Project Name: POCO #67
OCCC Campus Lighting Relay Control & Cabnt Replacement

Project Number: Y22-7039

**ORANGE COUNTY CONVENTION CENTER
CAPITAL PLANNING
SCHEDULE A: POTENTIAL CHANGE ORDER (PCO) COVER PAGE FOR PRIME CONTRACTOR**

PCO No. 67 **PROJECT:** OCCC Campus Lighting Relay Ctrl & Cabnt Repl **DATE:** 09/24/24

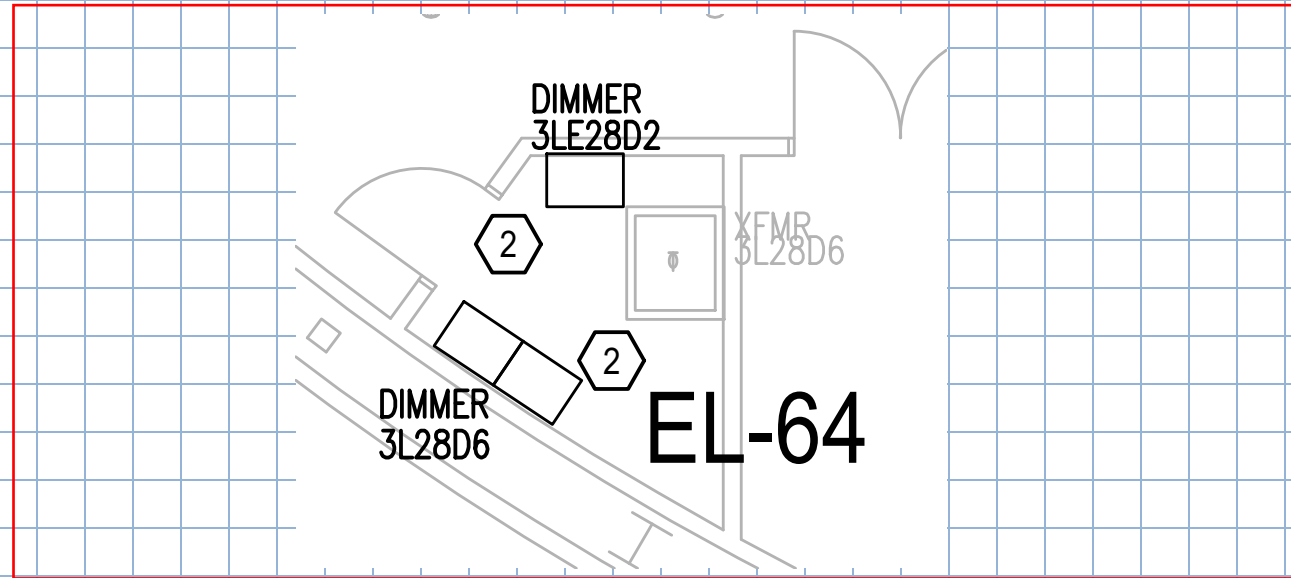
Question:
Per West_Drawings_VOL_4, West Bldg., 3rd Level, Area: ED2361, Room: EL-64, Panel: 3L28D6 a (1) SR48 dimmer rack with 36 dimmers and 6 non-dims was allotted for the scope of work. After surveying the area it was noted it actually requires (1) Aux Bay, (2) SR48 dimmer racks with 110 dimmer/non-dims. The load schedule is incorrect. This will require a change order.

Per West Drawings VOL 4, West Bldg., 3rd Level, Area: ED2361, Room: EL-64, Panel: 3L28D6 a (1) SR48 dimmer rack with 36 dimmers and 6 non-dims was allotted for the scope of work. After surveying the area it was noted it actually requires (1) Aux Bay, (2) SR48 dimmer racks with 110 dimmer/non-dims. The load schedule is incorrect. This will require a change order.

Response:
Dimming panel schedule sheet E705 issued during addendum 5 show quantity's of 115 dimming circuits . Per specifications section 260500 1.7 A Candela Controls requested additional site visit in addendum 3 to verify power feed requirements. specification section 260943 2.7,B,9 rack enclosures shall be designed for use with auxiliary racks for main circuit breaker. Work shall be done at no cost to the owner.

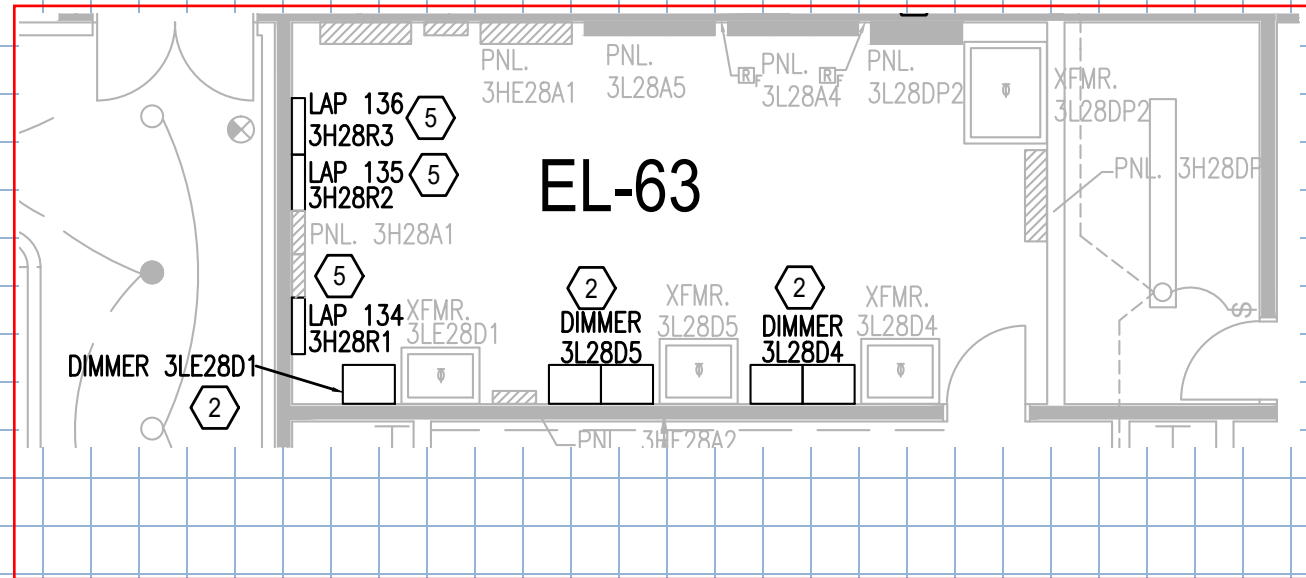
Question:
Per West_Drawings_VOL_4, West Bldg., 3rd Level, Area: ED2374, Room: EL-63, Panel: 3L28D4 a (1) SR12 with 18 dimmers and 6 non dims was allotted for the scope of work. After surveying the area it was noted that it actually requires (1) Aux Bay, (1) SR48 with 96 dimmer/non dims. This will require a change order.

Per West Drawings VOL 4, West Bldg., 3rd Level, Area: ED2374, Room: EL-63, Panel: 3L28D4 a (1) SR12 with 18 dimmers and 6 non dims was allotted for the scope of work. After surveying the area it was noted that it actually requires (1) Aux Bay, (1) SR48 with 96 dimmer/non dims. This will require a change order.

Originally Quoted: (1) SR12 with 18 dimmers and 6 non dims.

Response:
Dimming panel schedule sheet E705 issued during addendum 5 show quantity's of 96 dimming circuits . Per specifications section 260500 1.7 A Candela Controls requested additional site visit in addendum 3 to verify power feed requirements. specification section 260943 2.7,B,9 rack enclosures shall be designed for use with auxiliary racks for main circuit breaker. Work shall be done at no cost to the owner.

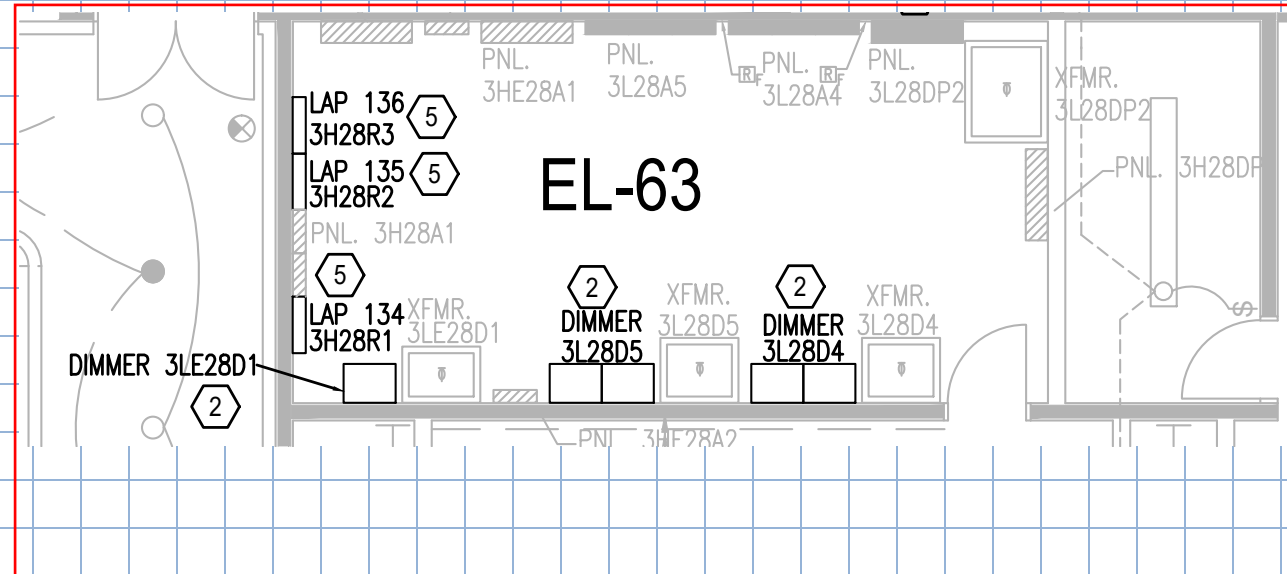
Question:
Per West_Drawings_VOL_4, West Bldg., 3rd Level, Area: ED2374, Room: EL-63, Panel: 3L28D5 a (1) SR12 with 18 dimmers and 6 non dims was allotted for the scope of work. After surveying the area it was noted that it actually requires (1) Aux Bay, (1) SR48 with 84 dimmer/non dims. This will require a change order.

Per West Drawings VOL 4, West Bldg., 3rd Level, Area: ED2374, Room: EL-63, Panel: 3L28D5 a (1) SR12 with 18 dimmers and 6 non dims was allotted for the scope of work. After surveying the area it was noted that it actually requires (1) Aux Bay, (1) SR48 with 84 dimmer/non dims. This will require a change order.

Originally Quoted: (1) SR12 with 18 dimmers and 6 non dims.

Response:
Dimming panel schedule sheet E705 issued during addendum 5 show quantity's of 71 dimming circuits . Per specifications section 260500 1.7 A Candela Controls requested additional site visit in addendum 3 to verify power feed requirements. Specification section 260943 2.7,B,9 rack enclosures shall be designed for use with auxiliary racks for main circuit breaker. Work shall be done at no cost to the owner.

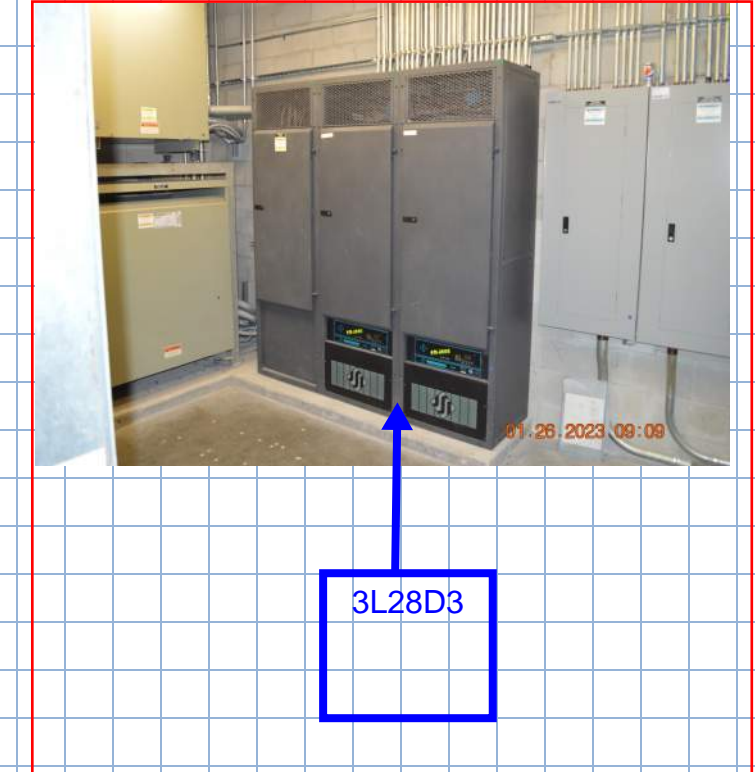
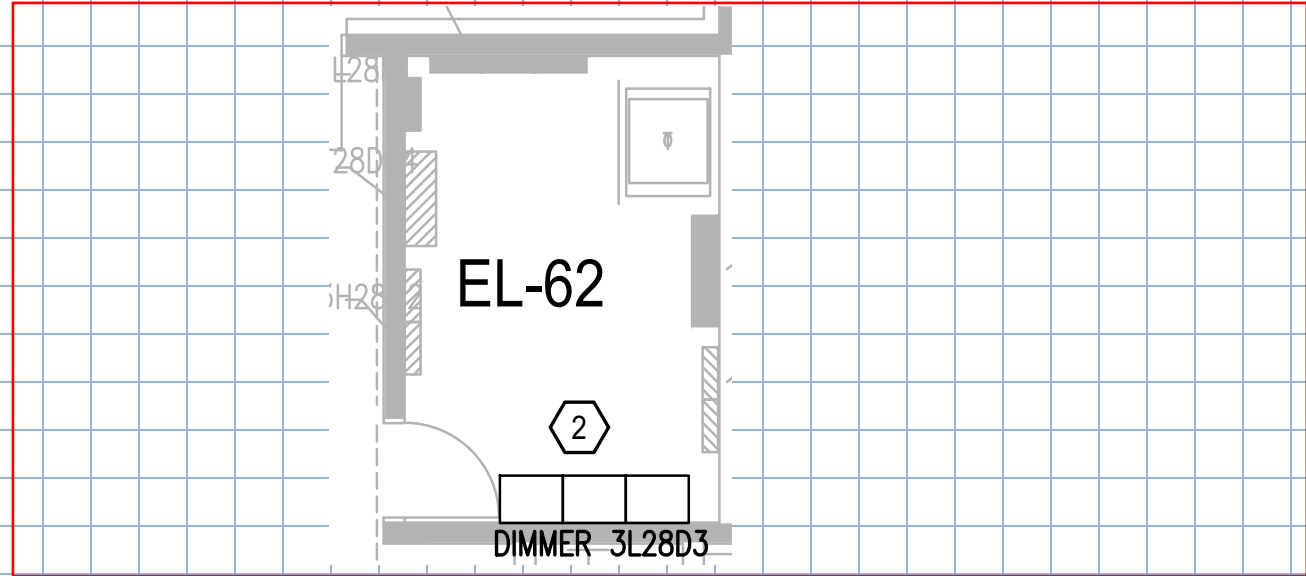
Question:
Per West_Drawings_VOL_4, West Bldg., 3rd Level, Area: ED2375, Room: EL-62, Panel: 3L28D3 a (1) SR12 dimmer rack with 18 dimmers and 6 non-dims was allotted for the scope of work. After surveying the area it was noted that it actually requires (1) Aux Bay, (2) SR48 with 126 dimmers/non-dims. This requires a change order.

Per West Drawings VOL 4, West Bldg., 3rd Level, Area: ED2375, Room: EL-62, Panel: 3L28D3 a (1) SR12 dimmer rack with 18 dimmers and 6 non-dims was allotted for the scope of work. After surveying the area it was noted that it actually requires (1) Aux Bay, (2) SR48 with 126 dimmers/non-dims. This requires a change order.

Originally Quoted: (1) SR12 dimmer rack with 18 dimmers and 6 non-dims.

Response:
Dimming panel schedule sheet E705 issued during addendum 5 show quantity's of 124 dimming circuits . Per specifications section 260500 1.7 A Candela Controls requested additional site visit in addendum 3 to verify power feed requirements. specification section 260943 2.7,B,9 rack enclosures shall be designed for use with auxiliary racks for main circuit breaker. Work shall be done at no cost to the owner.

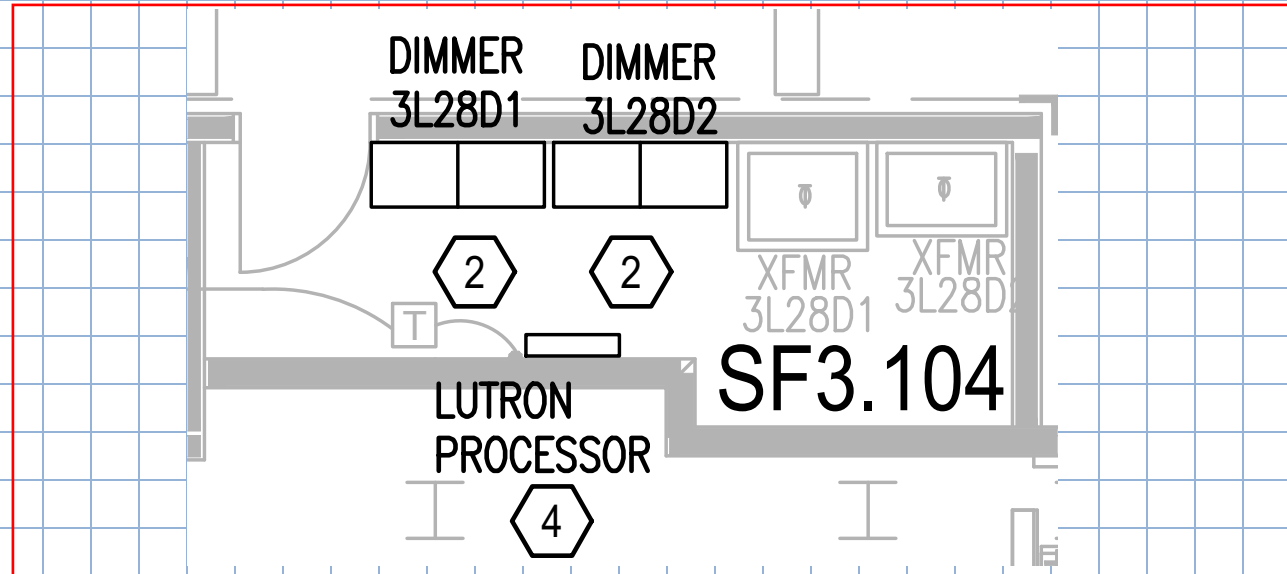
Question:
Per West_Drawings_VOL_4, West Bldg., 3rd Level, Area: ED2375, Room: SF3.104 EL-112, Panel: 3L28D2 a (1) SR12 dimmer rack with 18 dimmers and 6 non-dims was allotted for the scope of work. After surveying the area it was noted that it actually requires (1) Aux Bay, (1) SR48 with 48 dimmers/non-dims. This requires a change order.

Per West Drawings VOL 4, West Bldg., 3rd Level, Area: ED2375, Room: SF3.104 EL-112, Panel: 3L28D2 a (1) SR12 dimmer rack with 18 dimmers and 6 non-dims was allotted for the scope of work. After surveying the area it was noted that it actually requires (1) Aux Bay, (1) SR48 with 48 dimmers/non-dims. This requires a change order.

Originally Quoted: (1) SR12 dimmer rack with 18 dimmers and 6 non-dims.

Response:
Dimming panel schedule sheet E705 issued during addendum 5 show quantity's of 44 dimming circuits . Per specifications section 260500 1.7 A Candela Controls requested additional site visit in addendum 3 to verify power feed requirements. specification section 260943 2.7,B,9 rack enclosures shall be designed for use with auxiliary racks for main circuit breaker. Work shall be done at no cost to the owner.

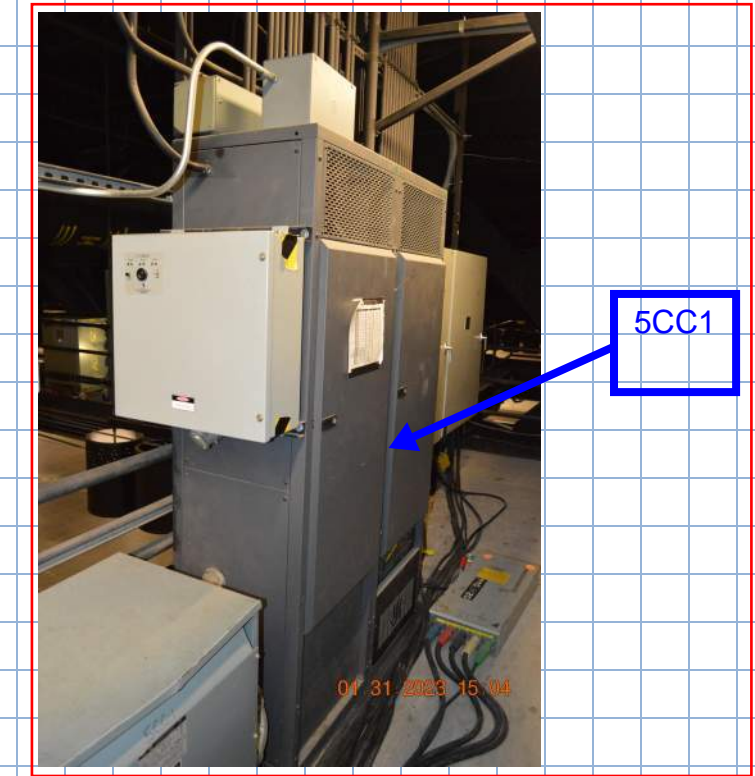
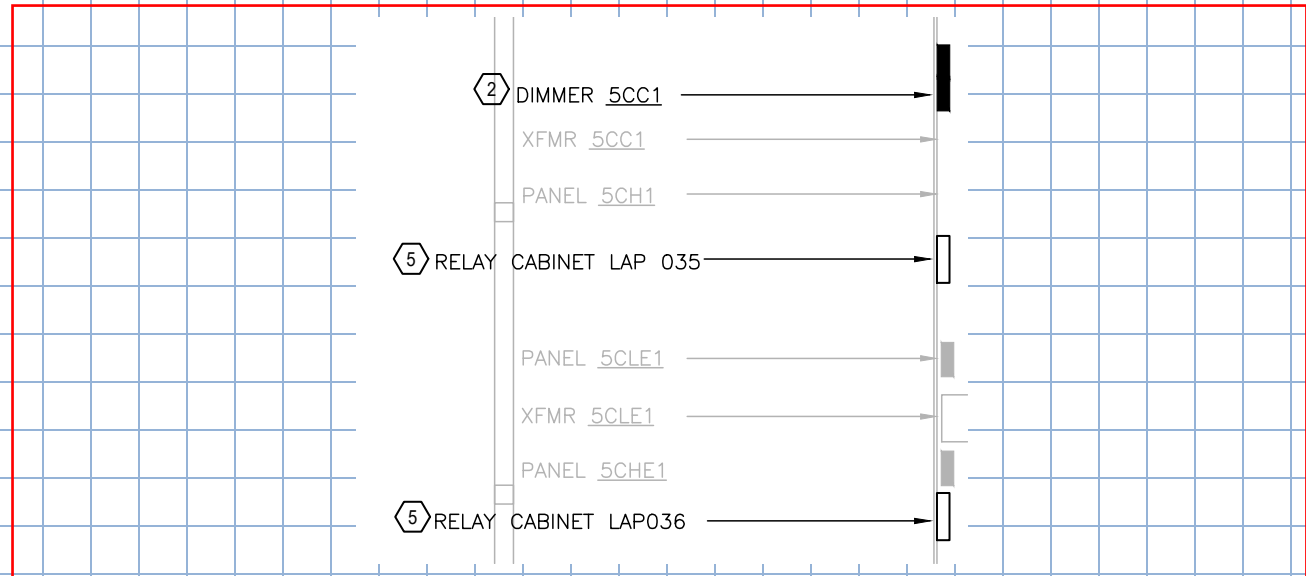
Question:
Per West_Drawings_VOL_4 E 706, West bldg., 4th Level, Area: ED2420, Room: HALL B1 N CAT, Panel: 5CC1 a (1) SR12 with 18 dimmers and 6 non-dims was allotted to the scope of work / After surveying the area it was noted that it actually requires (1) Aux Bay, (1) SR48, 42 dimmer/non-dims. This requires a change order.

Per West Drawings VOL 4 E 706, West bldg., 4th Level, Area: ED2420, Room: HALL B1 N CAT, Panel: 5CC1 a (1) SR12 with 18 dimmers and 6 non-dims was allotted to the scope of work / After surveying the area it was noted that it actually requires (1) Aux Bay, (1) SR48, 42 dimmer/non-dims. This requires a change order.

Originally Quoted: (1) SR12 with 18 dimmers and 6 non-dims.

Response:
Dimming panel schedule sheet E706 show a quantity's of 49 dimming circuits . Per specifications section 260500 1.7 A Candela Controls requested additional site visit in addendum 3 to verify power feed requirements. specification section 260943 2.7,B,9 rack enclosures shall be designed for use with auxiliary racks for main circuit breaker. Work shall be done at no cost to the owner.

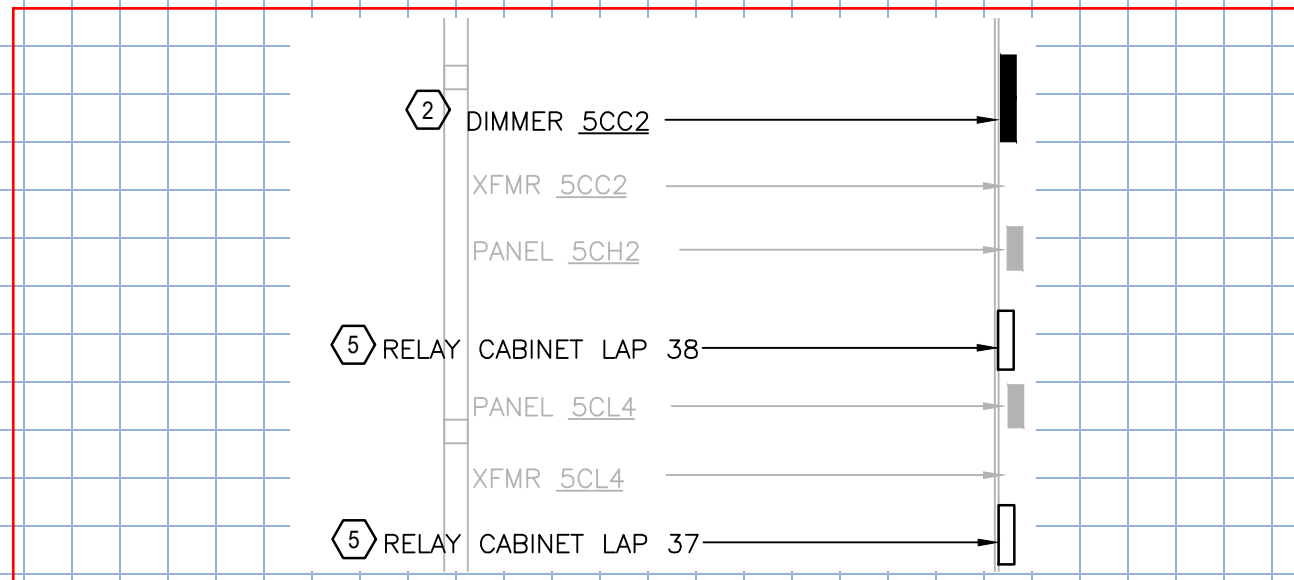
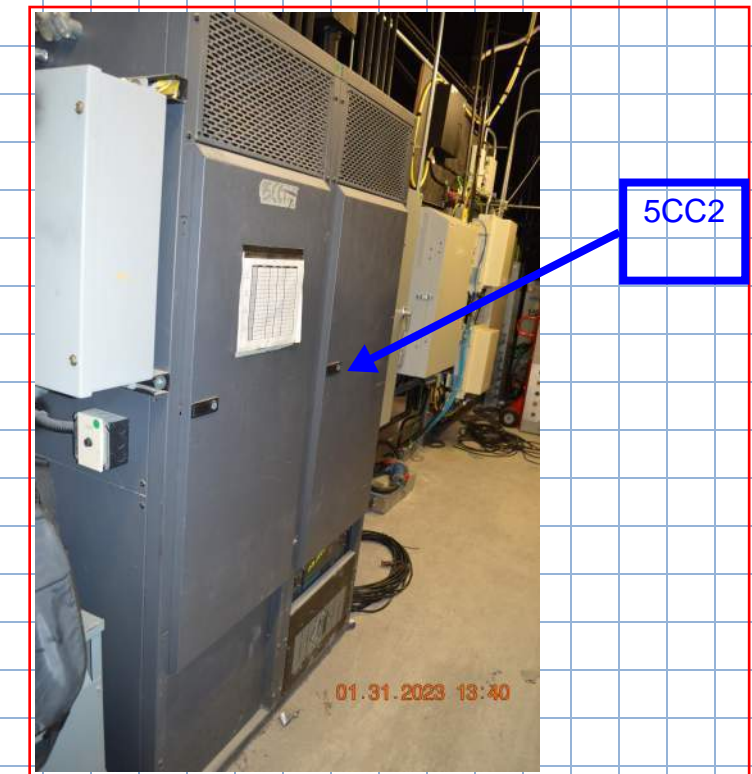
Question:
Per West_Drawings_VOL_4 E706, West Bldg., 4th Level, Area: ED2421, Room: HALL B3 N CAT, Panel: 5CC2 a (1) SR12 with 18 dimmers and 6 non-dims was allotted for the scope of work. After surveying the area it was noted that it actually requires (1) Aux Bay, (1) SR48, 40 dimmer/non-dims. This requires a change order.

Per West Drawings VOL 4 E706, West Bldg., 4th Level, Area: ED2421, Room: HALL B3 N CAT, Panel: 5CC2 a (1) SR12 with 18 dimmers and 6 non-dims was allotted for the scope of work. After surveying the area it was noted that it actually requires (1) Aux Bay, (1) SR48, 40 dimmer/non-dims. This requires a change order.

Originally Quoted: (1) SR12 with 18 dimmers and 6 non-dims.

Actually Requires: (1) Aux Bay, (1) SR48, 40 dimmer/non-dims.

Response:
Dimming panel schedule sheet E706 show a quantity's of 49 dimming circuits . Per specifications section 260500 1.7 A Candela Controls requested additional site visit in addendum 3 to verify power feed requirements. specification section 260943 2.7,B,9 rack enclosures shall be designed for use with auxiliary racks for main circuit breaker. Work shall be done at no cost to the owner.

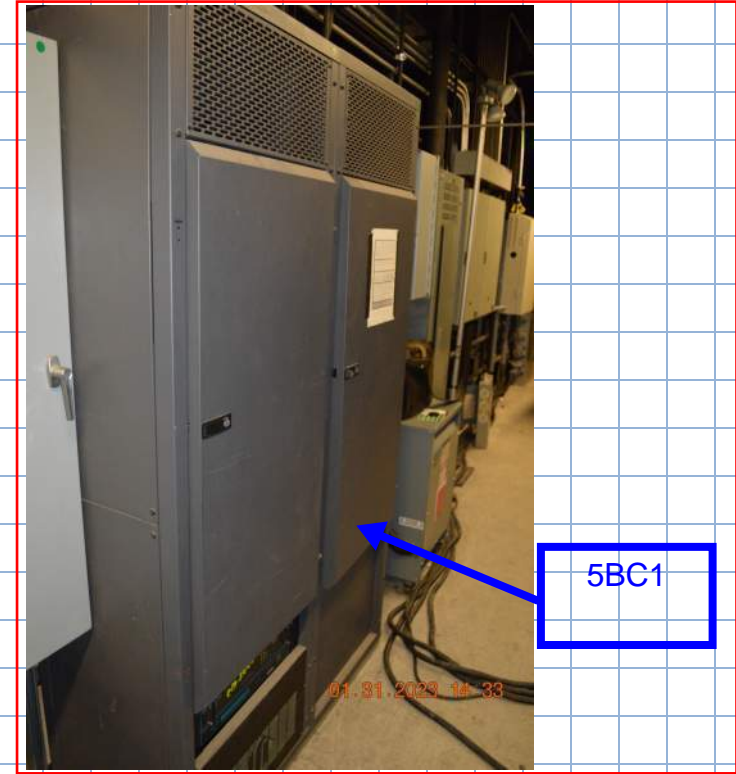
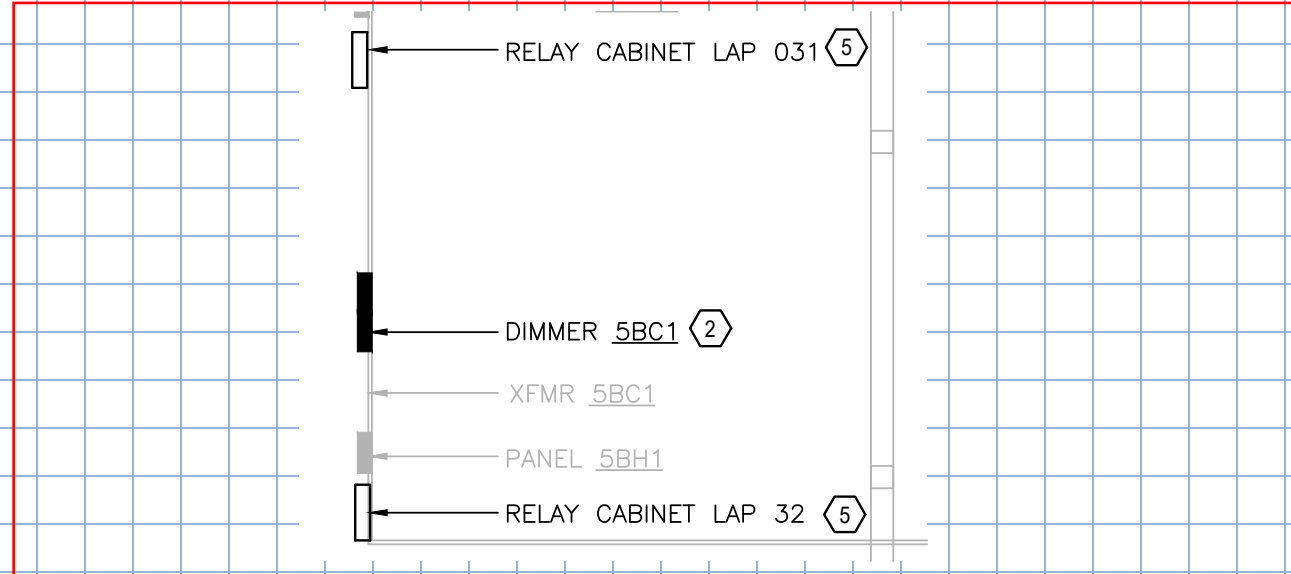
Question:
 Per West_Drawings_VOL_4 E706, West Bldg., 4th Level, Area: ED2428, Room: HALL B2 S CAT, Panel: 5BC1 a (1) SR12 With 18 dimmers and 6 non-dims was allotted for the scope of work. After surveying the area it was noted that it actually requires (1) Aux Bay, (1) SR48 and 36 dimmer/non-dims. This requires a change order.

Per West Drawings VOL 4 E706, West Bldg., 4th Level, Area: ED2428, Room: HALL B2 S CAT, Panel: 5BC1 a (1) SR12 With 18 dimmers and 6 non-dims was allotted for the scope of work. After surveying the area it was noted that it actually requires (1) Aux Bay, (1) SR48 and 36 dimmer/non-dims. This requires a change order.

Originally Quoted: (1) SR12 With 18 dimmers and 6 non-dims.

Response:
 Dimming panel schedule sheet E706 show a quantity's of 49 dimming circuits . Per specifications section 260500 1.7 A Candela Controls requested additional site visit in addendum 3 to verify power feed requirements. specification section 260943 2.7,B,9 rack enclosures shall be designed for use with auxiliary racks for main circuit breaker. Work shall be done at no cost to the owner.
